Response to LRD Opinion

Proposed Large Scale Residential Development (LRD) at the Site of the Former DELL EMC Premises, Innishmore, Ballincollig, Cork

Figure 2.2 Proposed Development 2hr Sunlight Test. [Source: Daylight and Sunlight Assessment, prepared by BPC Engineers]

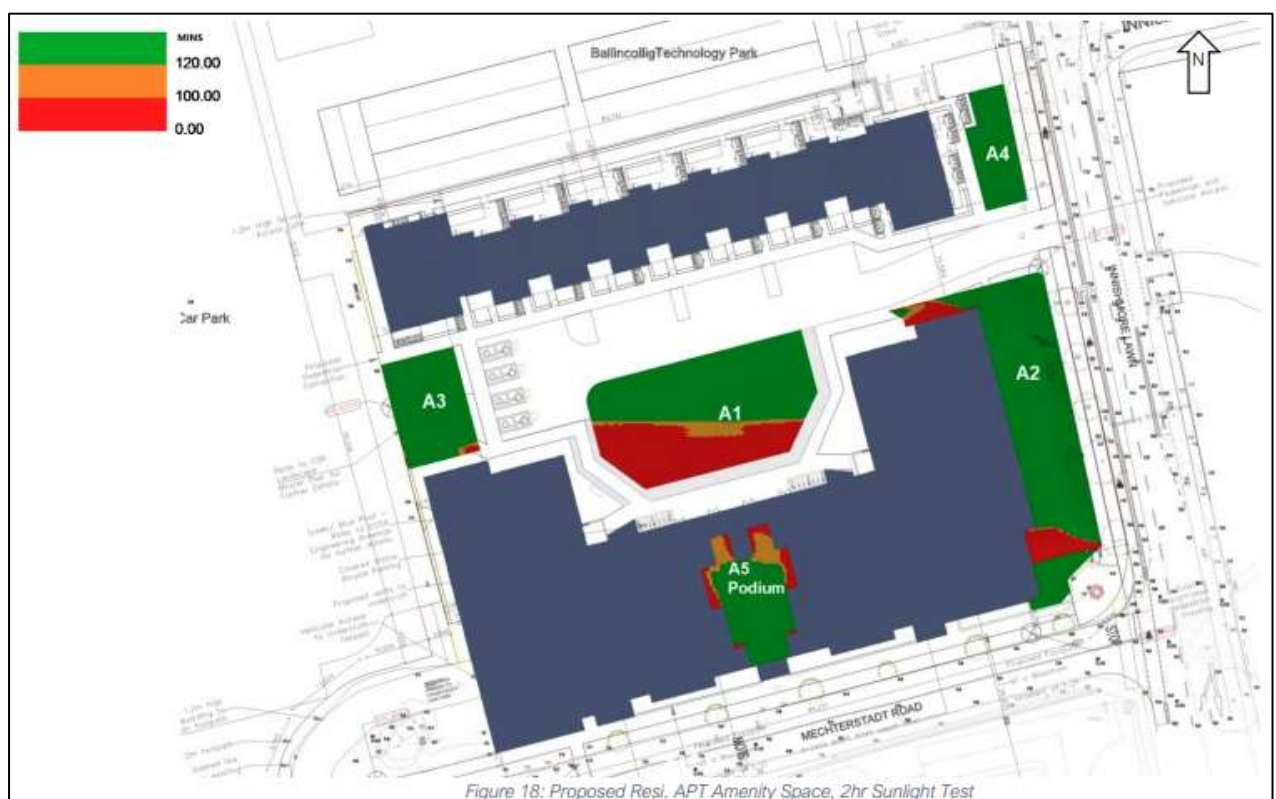
In order to assist with an informed appraisal of the overall scheme and the impact of the height of the southern blocks on the extent of daylight to the courtyard space, a comparative Daylight/Sunlight study should be made of the impact of a 4, 5 and 6 storey scheme on the quality of the proposed public open space. Alternative proposals such as omission/reduction of surface level car parking and/or relocation of the public open space area should be considered. The Planning Authority would welcome further discussion on this aspect of the development prior to the lodging of any planning application.

Notwithstanding this, the submitted assessment comprehensively evaluates the performance of the proposed scheme and demonstrates that the courtyard and public open space achieve appropriate levels of daylight and sunlight having regard to established BRE guidance and best practice methodologies. The assessment confirms that the quality of the proposed public open space will be acceptable and fit for purpose, providing a usable and well-designed amenity area for future residents.

The accompanying assessment evaluates the proposed development's principal communal open spaces against the BRE Guidelines for daylight and sunlight. The assessment concludes that the proposed open spaces exceed the recommended sunlight criteria, with these areas receiving more than two hours of sunlight on 21st March, in accordance with best practice standards.

Figure 3.19 Proposed SUDS Measures Layout. Includes extract of the Green/Blue Roof net attenuation. [Source: Proposed SUDS Measures Layout (Drawing Ref. 6709-0050-D), and the Drainage Impact Assessment, prepared by DOSA Engineers. Cropped and annotated by TPA 2026]

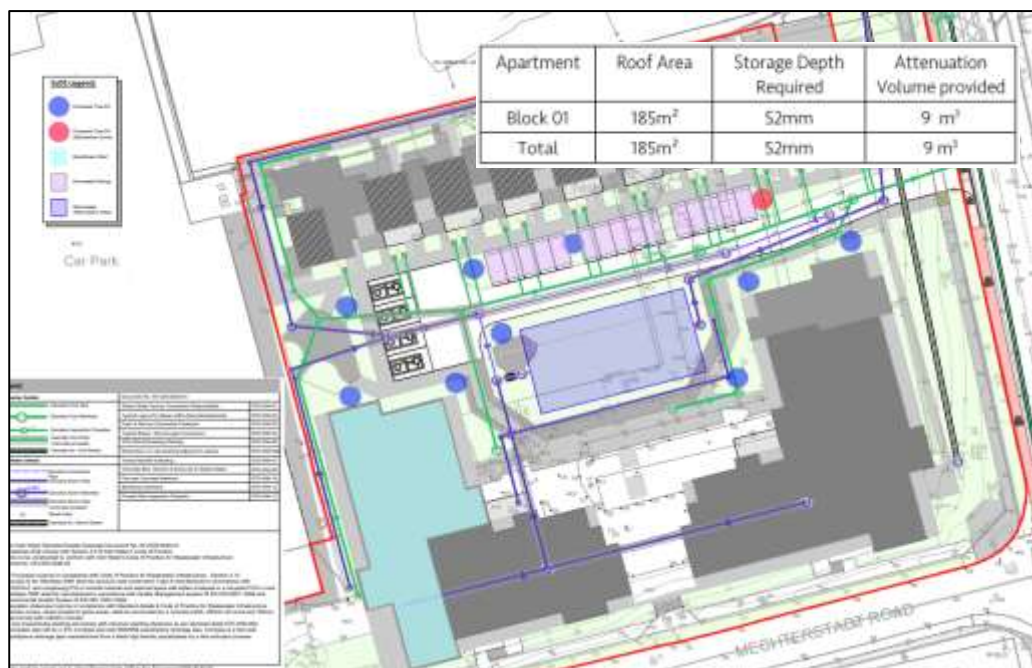
- *No tree planting should take place over any attenuation tanks;*
- *The provision of green/blue roofs to the apartment blocks including full details of same;*

For details regarding the proposed development's blue/green roof provision, please refer to Section 2.2.5 of the Drainage Impact Assessment and the enclosed drawing, "Proposed SuDS Measures Layout" (Drawing Ref. 6709-0050-D), prepared by DOSA Engineers.

Figure 3.19 Open Space Typologies. The extracts above highlight the proposed play areas. Includes text extract from section 02 of the submitted Landscape Design Rationale. [Source: Landscape Design Rationale, prepared by CSR, cropped and annotated by TPA 2026]

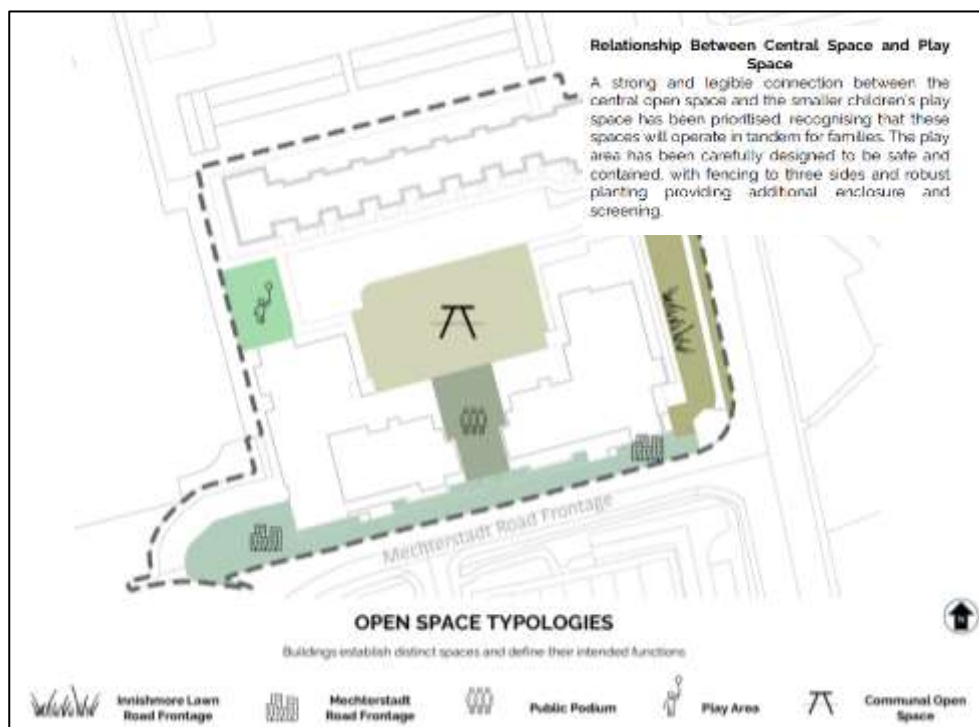
- *A Hardscape Plan including materials and species number type and size prioritising the use of native species;*
- *Full details on the proposed play area including finishes and play equipment to relevant standards and maintenance details;*

Please refer to Section 02 of the Landscape Design Rationale and the Landscape Masterplan (Drawing Ref. 25108-1-101) prepared by CSR for the full details of the proposed development's play areas. The proposed development includes a natural play area to the west of the site, which has been integrated with the site's nature-based SuDS.

Figure 4.9.2 Proposed Site Layout – Parking Provision. [Source: Architectural Design Statement prepared by Meitheal Architects, cropped by TPA 2026]

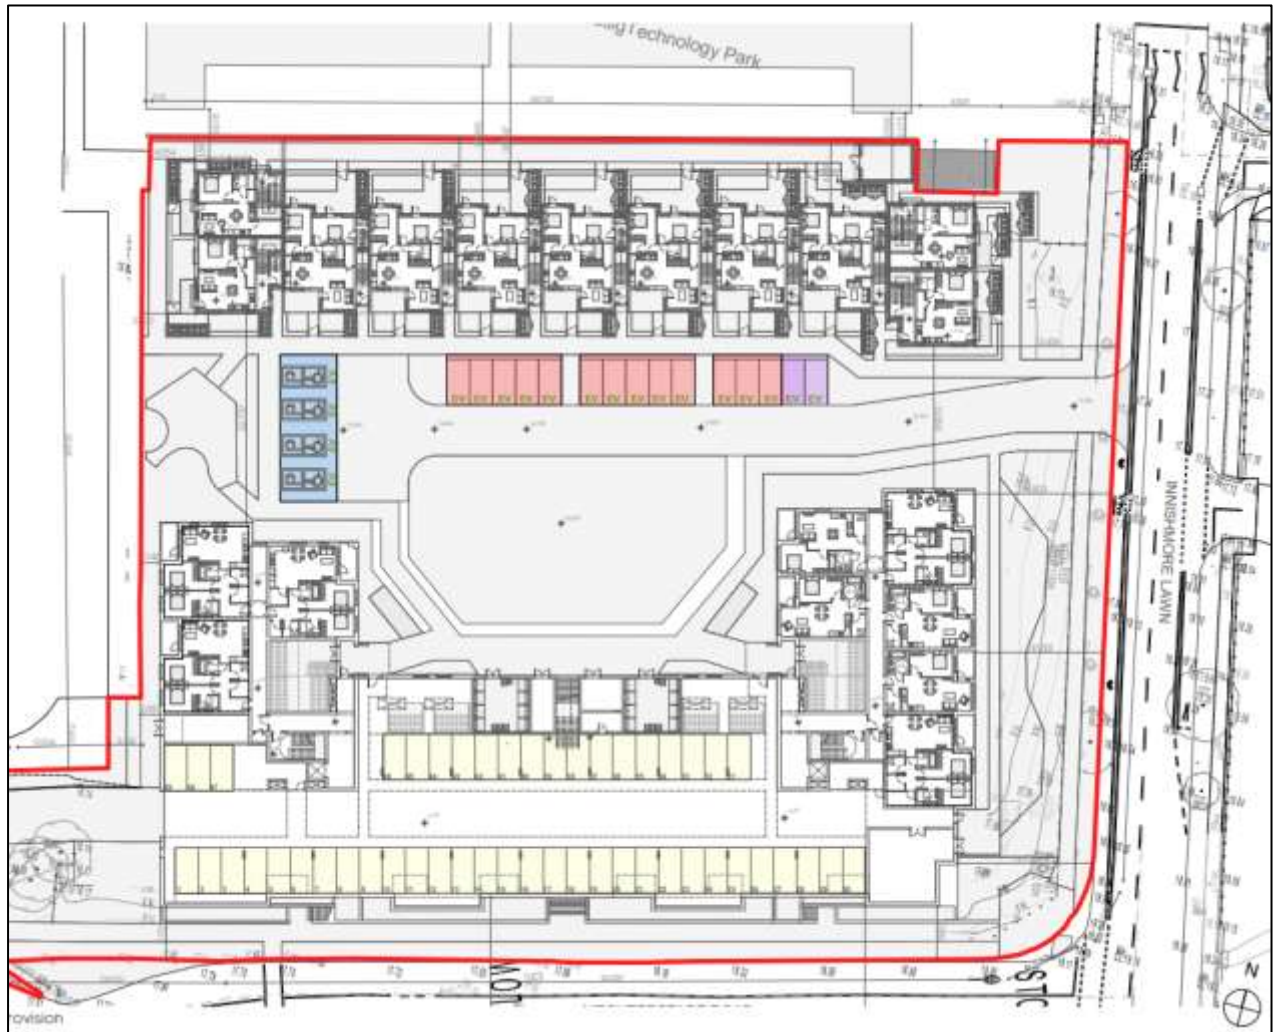
"Revised drawings and details to address the requirements and concerns of the S.E.E. (Urban Roads and Street Design Section in relation to taking in charge and EV spaces".

Please note that none of the proposed development's car parking spaces will be taken in charge by the Local Authority. Therefore, they will not be available for public use and are intended for the communal use of future residents and visitors. These spaces will be maintained by a private management company.

Please refer to Section 10.4 of the accompanying Architectural Design Statement for details of the proposed development's parking provision, including a breakdown of EV spaces. The development provides a total of 68 no. car parking spaces, of which 19 no. are designated for EVs. We would like to highlight to the Local Authority that this exceeds the *Development Plan's* requirement of 14 no. spaces for a development of this scale.
